# Value Engineering Study Report

## Georgia Department of Transportation

I-20 Eastbound from I-285 to CR 5150/Panola Road

Collector Distributor System • P.I. No. 0009542

ALTERNATIVE NO.:  
**AC-1**

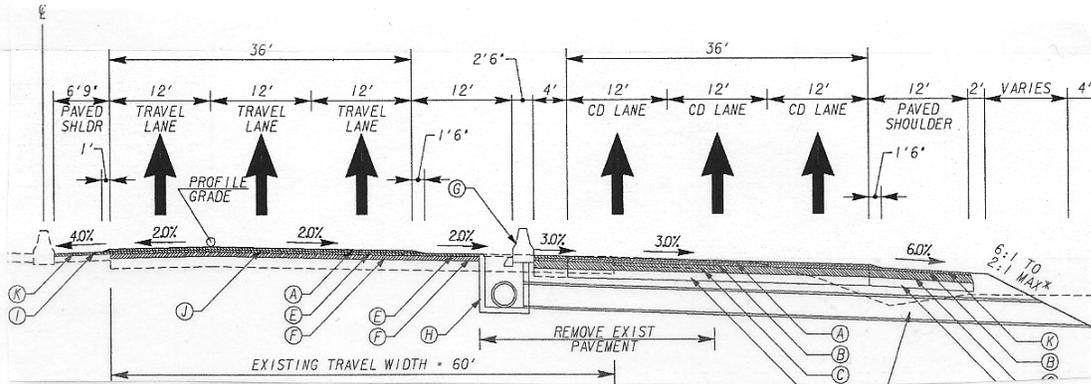
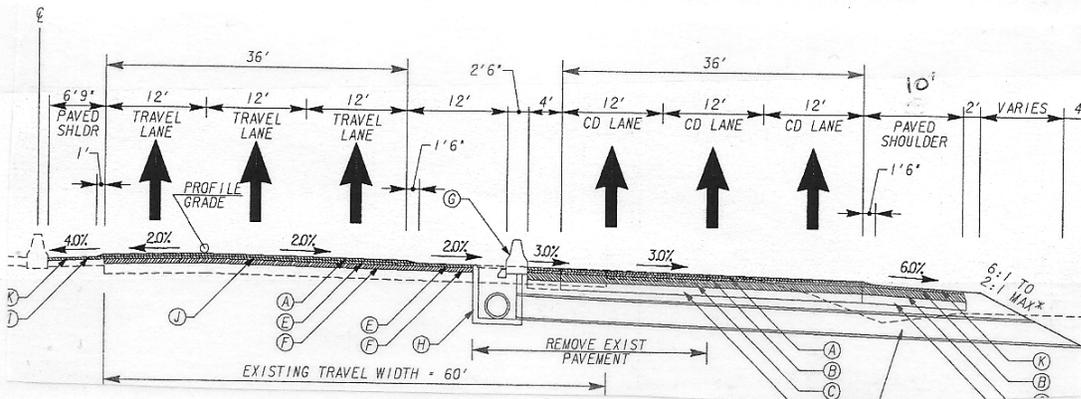
The original design proposes constructing 12' outside shoulders for the length of the CD lanes.

The alternative proposes using 10' paved outside shoulders for the length of the CD lanes.

Since the outside shoulder is not on the I-20 mainline alignment, and the design speed of the CD lanes is 55 mph, the alternative suggests using a 10' outside paved shoulder width. The alternative would reduce paving costs incurred by 2' of full depth pavement in the outside shoulder section for the length of the CD lanes.

ALTERNATIVE NO.:  
**AC-3**

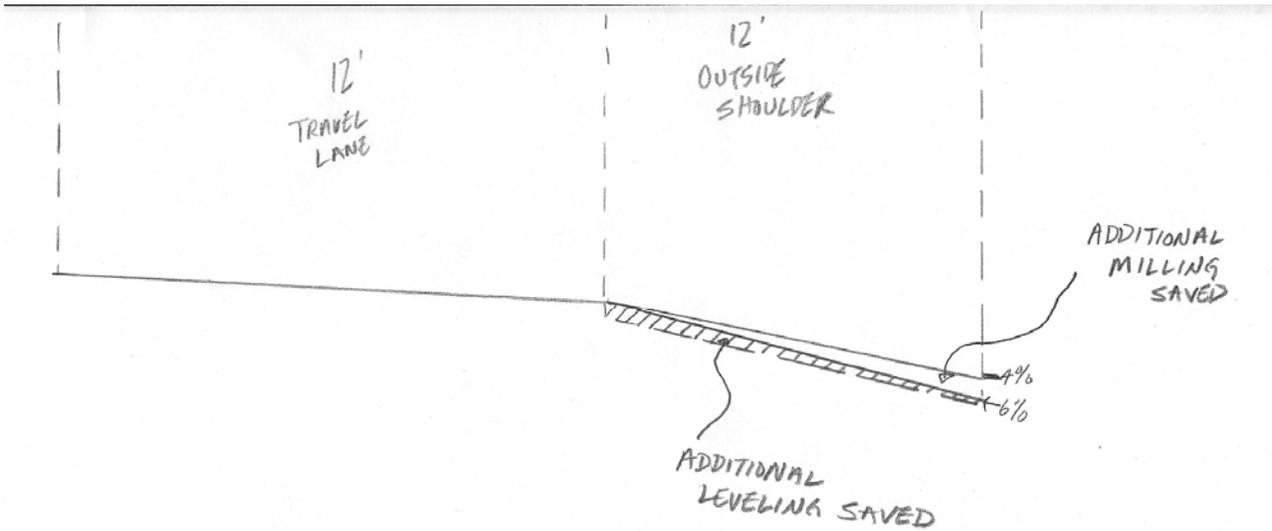
The original design calls for construction of the outside shoulders with full depth pavement at a cross-slope of 6% in tangent sections.

The alternative proposes to construct the outside shoulders with full depth pavement with a cross-slope of 4% in tangent sections.

The alternative proposes using 4% cross slopes on the outside shoulder in tangent sections instead of the originally designed cross-slope of 6%. The intent is to reduce future work required for widening the shoulders for travel lane usage. By constructing the outside shoulders at 4%, future milling and leveling is reduced by minimizing the “wedge” area to mill and level prior to seal overlay to correct cross-slope for travel lanes at 2% in tangent sections (see Illustration). An identified risk is that the reduction in cross slope of the outside shoulder from 6% to 4% may have an adverse effect to sheet flow drainage across the existing travel lanes.

ALTERNATIVE NO.:  
**MS-3**

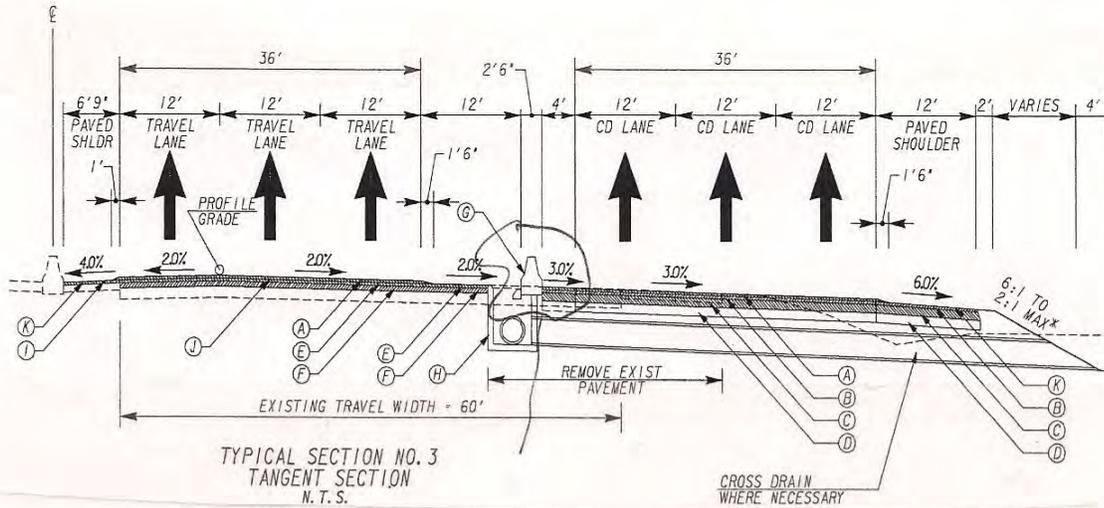
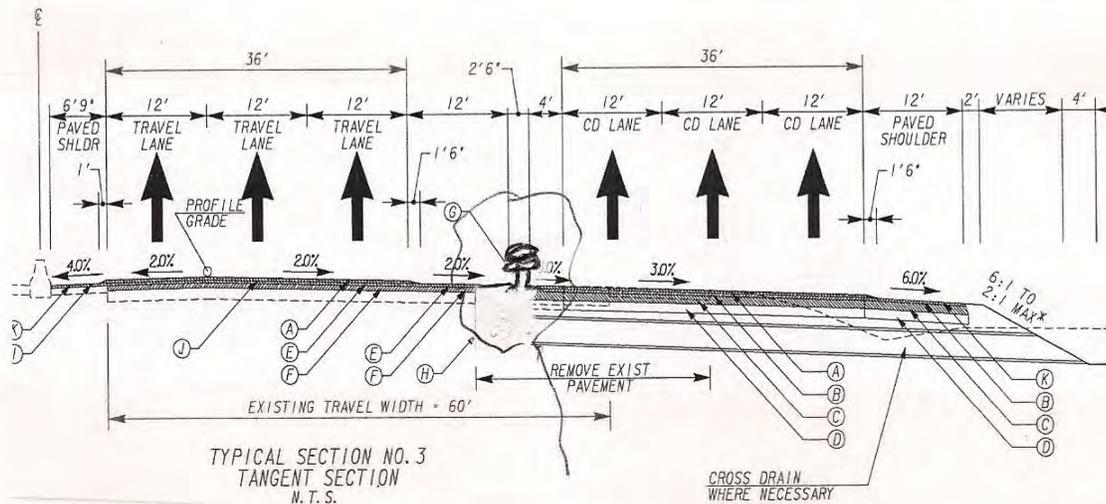
The original design proposes constructing a Type 26 Concrete Median Barrier for positive separation between the general purpose and CD lanes from approximate STA 65+00 to approximate STA 135+00.

The alternative proposes using double-faced guardrail, Type W in-lieu of concrete barrier rail.

The alternative proposes using double-faced guardrail to separate the CD lanes from the GP lanes. The cost savings derived represent a reduction in cost per unit for the guardrail compared to the concrete median barrier. The original design contemplates drop inlets adjacent to the barrier rail to a closed drainage system. The alternative, if implemented, provides the opportunity for exploring other methods for conveying the drainage which may reduce costs further. For future widening on I-20, removal of the guardrail would be less expensive and easier to utilize than removing the concrete median. First cost savings by using the guardrail instead of the concrete median may be diminished by an increase in maintenance costs by repairing/replacing damaged sections of guardrail.

ALTERNATIVE NO.:  
**MS-4**

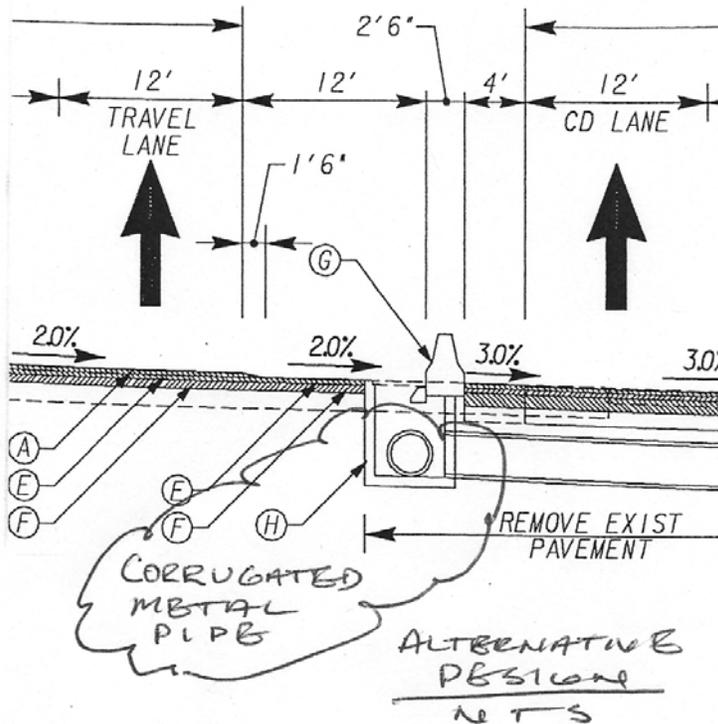
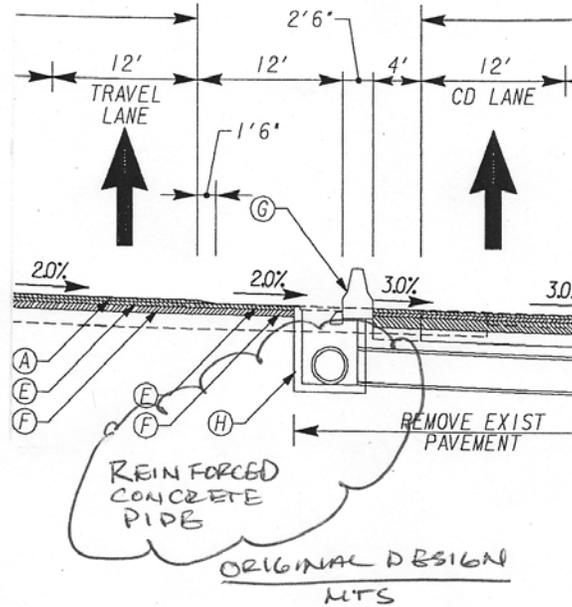
PROJECT:	<b>Georgia Department of Transportation</b> <b>P.I. No. 0009542</b> <b>I-20 Eastbound from I-285 to CR 5150/Panola Road – Collector Distributor System, DeKalb County</b>	ALTERNATIVE NO.:	<b>MS-4</b>
DESCRIPTION:	<b>Use Corrugated Metal Pipe for CD Road drainage.</b>	SHEET NO.:	<b>4 of 4</b>

DESCRIPTION: **Use MSE walls in-lieu of cast-in-place concrete retaining walls**

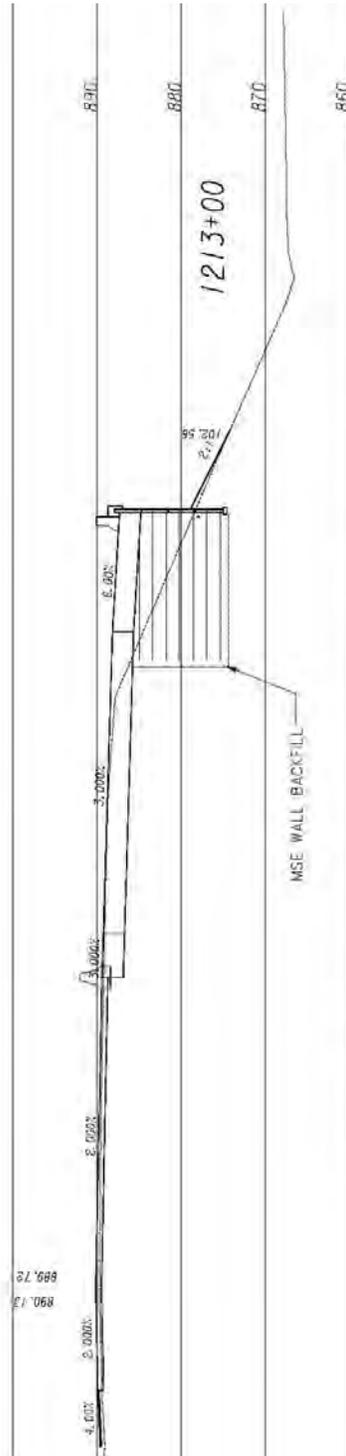
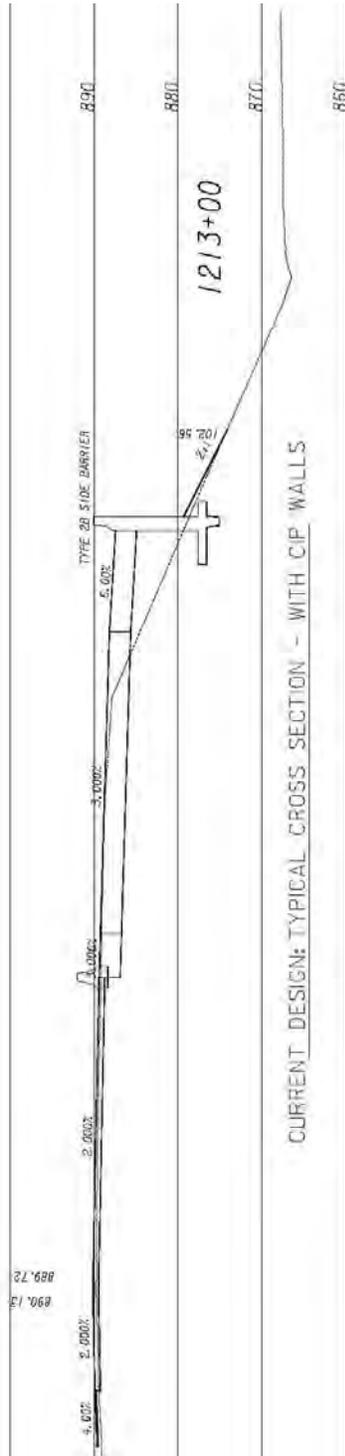
DESCRIPTION: **Use MSE walls in-lieu of cast-in-place concrete retaining walls** SHEET NO.: **1 of 4**

DESCRIPTION: **Use sheet piles in-lieu of cast-in-place concrete retaining walls**

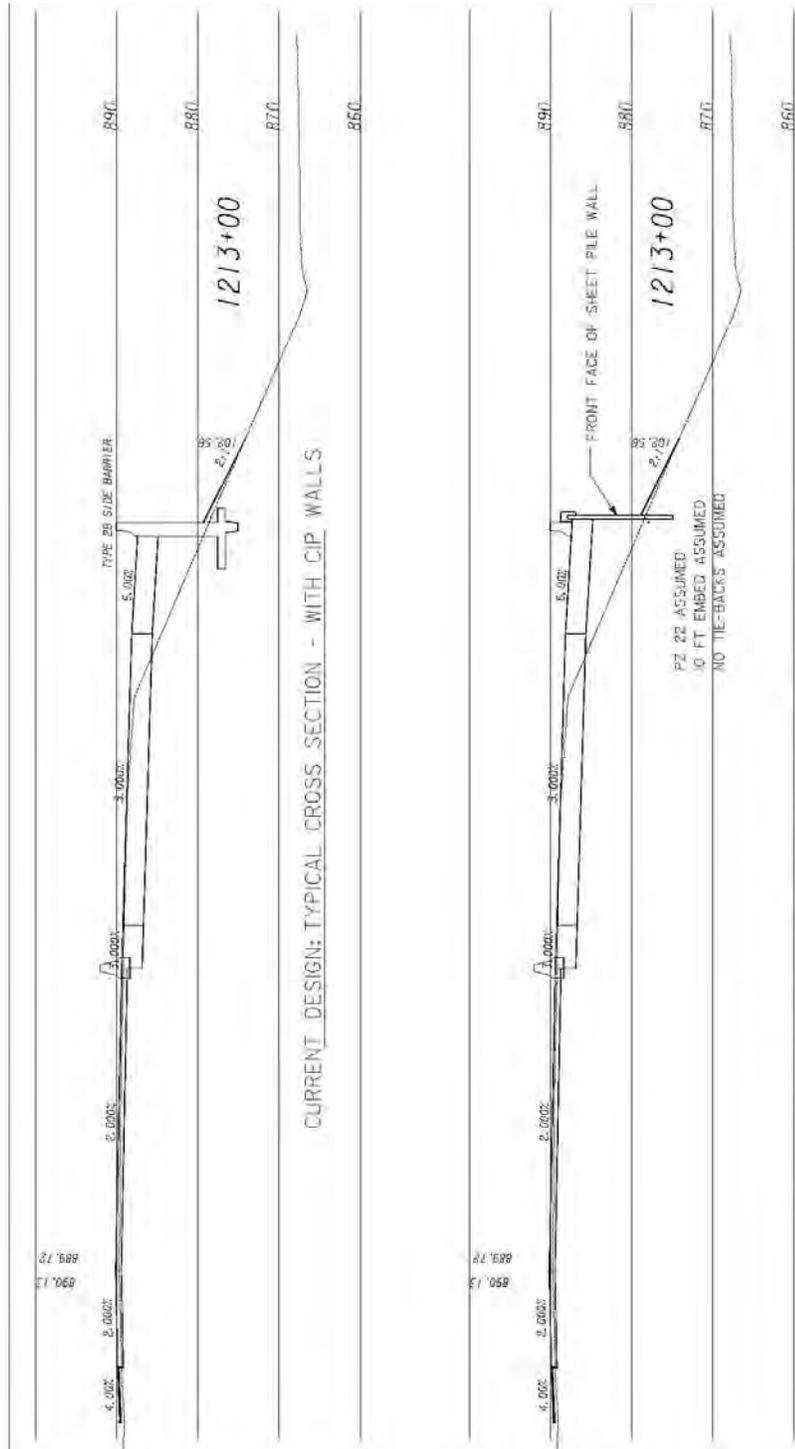
The alternative proposes the use of sheet piles in-lieu of the cast-in-place retaining walls. The alternative maintains the original design wall envelope and geometry.

Keeping in perspective the long range plan for improvements to this corridor which would result in the demolition of the cast-in-place retaining walls, the reusability of sheet piles is an added advantage that could result in future cost savings.

Coping could be provided on the sheet piles for improved aesthetics.
